RESOLUTION NO. 12-10

RESOLUTION OF THE TOWN OF ST. LEO TOWN COMMISSION  
APPROVING SAINT LEO UNIVERSITY INC. AND HOLY NAME ACADEMY  
SITE PLAN/VARIANCE REVIEW (SPR#12-B/VAR #12-A) WITH CONDITIONS.

**SITE PLAN (SPR)/VARIANCE (VAR) REVIEW STAFF REPORT  
Site Plan Review (SPR#12-B) and Variance Request (VAR #12-A)  
June 11, 2012 Public Hearing**

A-001

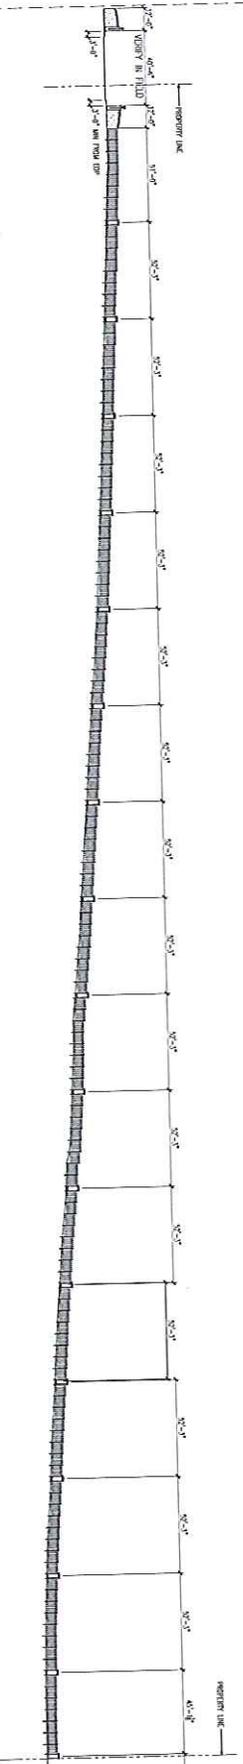
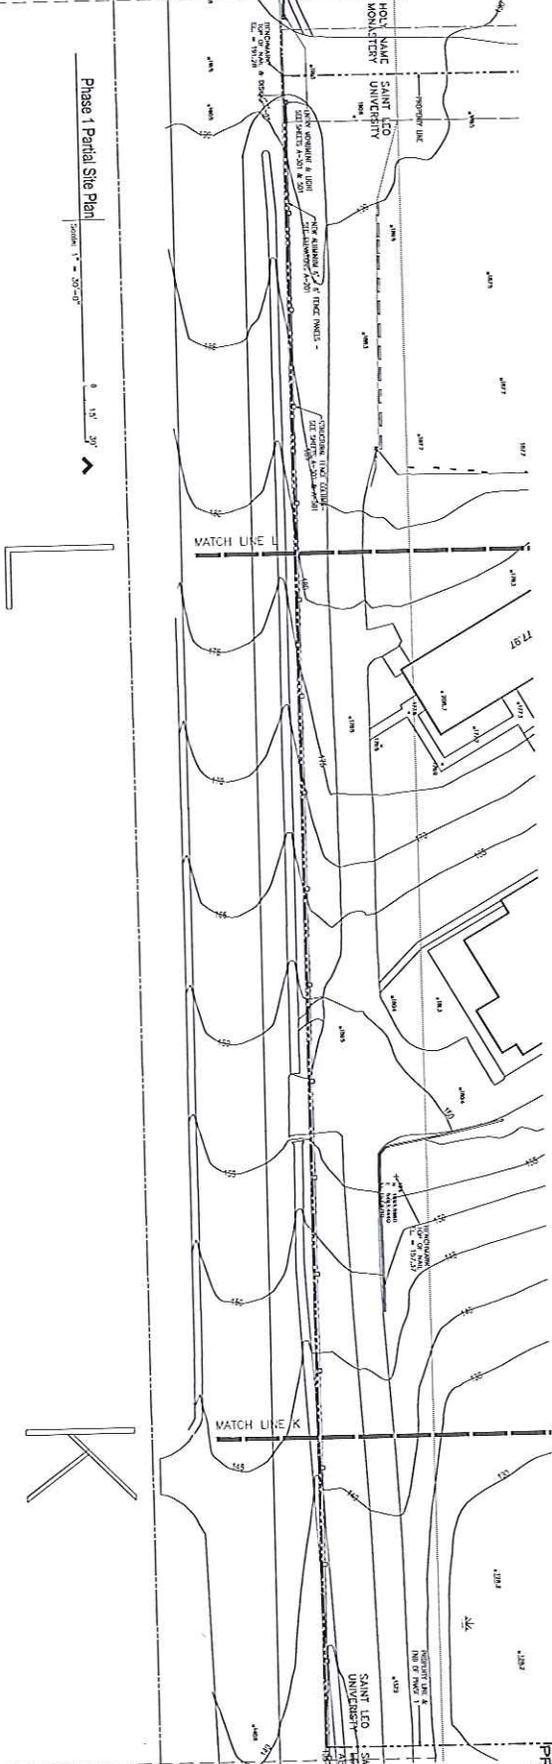
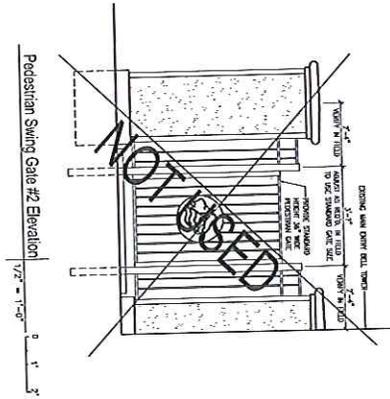
The project is planned in three phases: however, only Phases 1 and 3 are being submitted for approval at this time. The Applicant has not identified any timetable for these phases. The proposed fence project does not include the properties owned by the Order of Saint Benedict of Florida (as noted on Sheet A-001, which deletes Phase 2) or the segment of University owned S.R. 52 frontage adjacent to the wetland at the eastern boundary of the University property (Phase 4). As noted, these segments of S.R. 52 frontage are not part of this fence height variance request. In the future, if the University wishes to construct these segments of the fence, a future variance request will be required.

Drawing A-001 shows the Entry Monument, half of which is on Holy Name Monastery property, and Phase 1 Fencing which stops at the university's property line.

1201.03  
 A-201

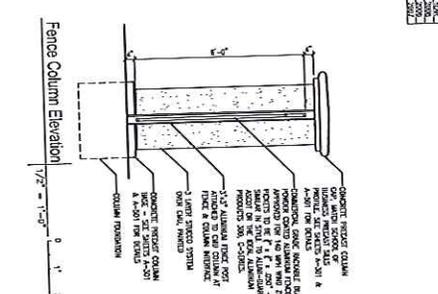
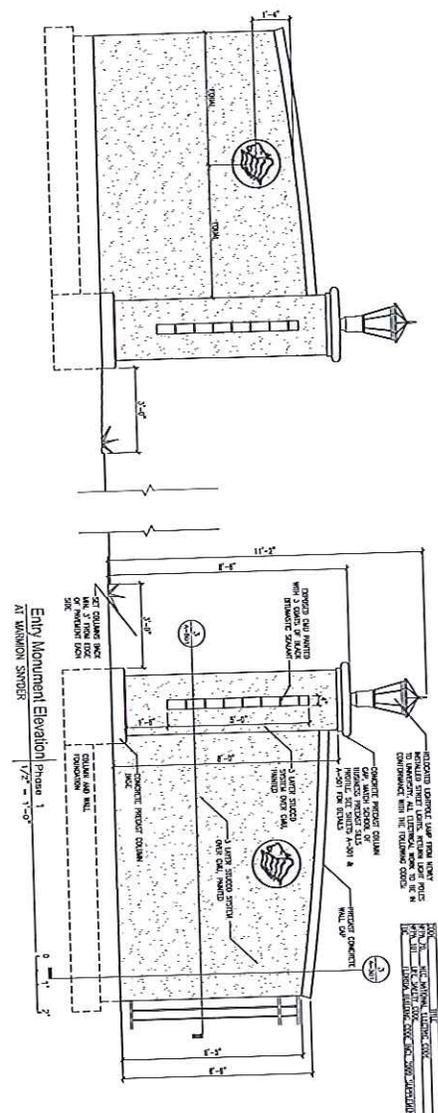
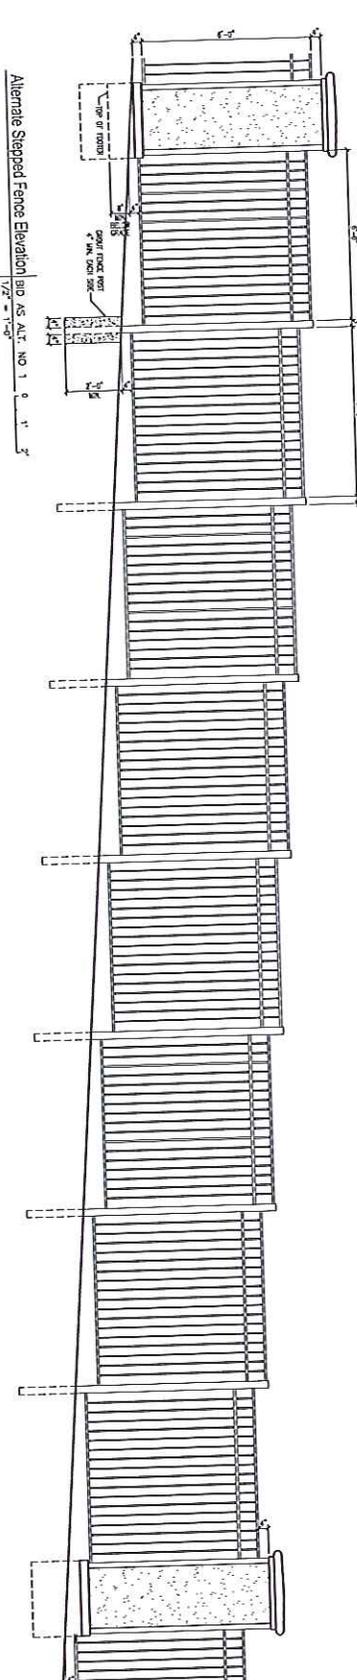
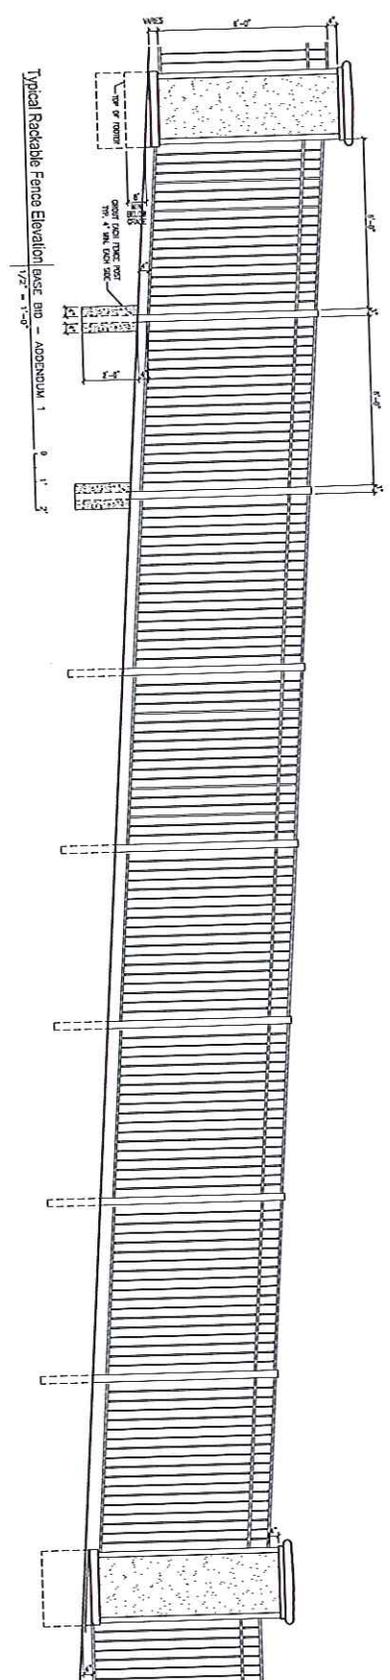
Drawing A-202 shows Gate Elevations.

1201.03  
 A-301

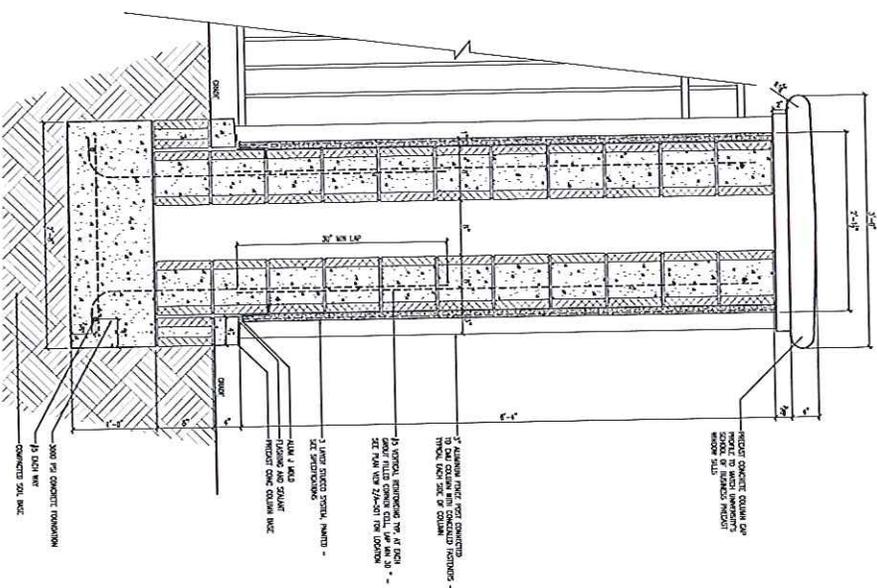
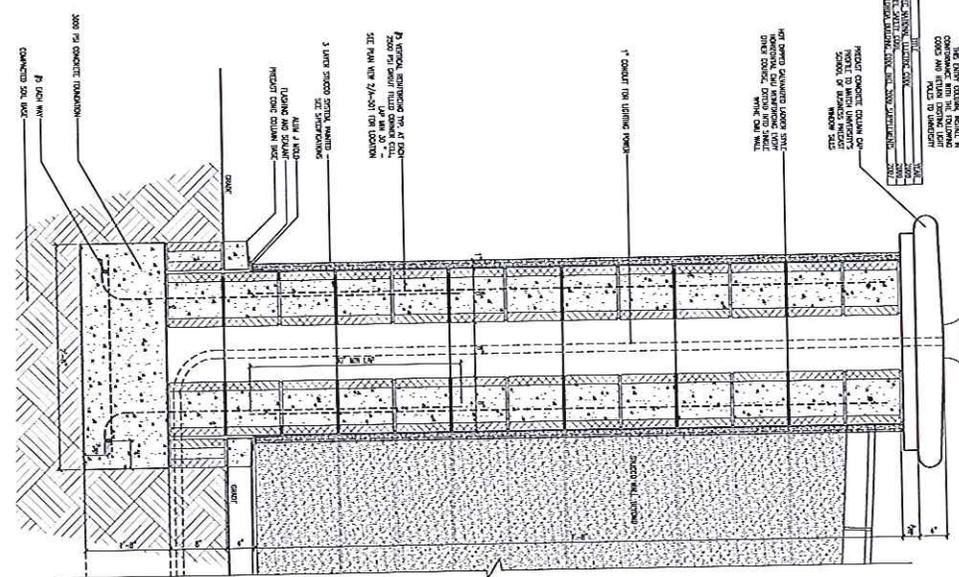
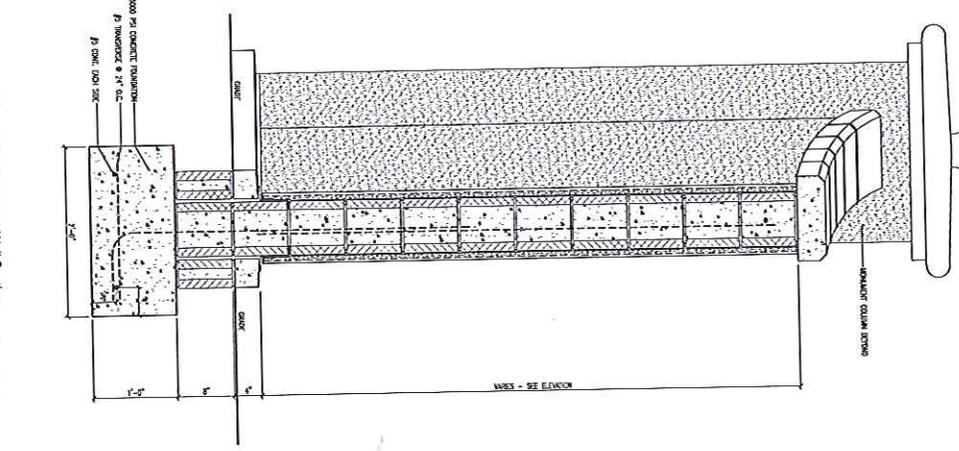
Drawings A-301 and A-501 show Construction Sections and Details.
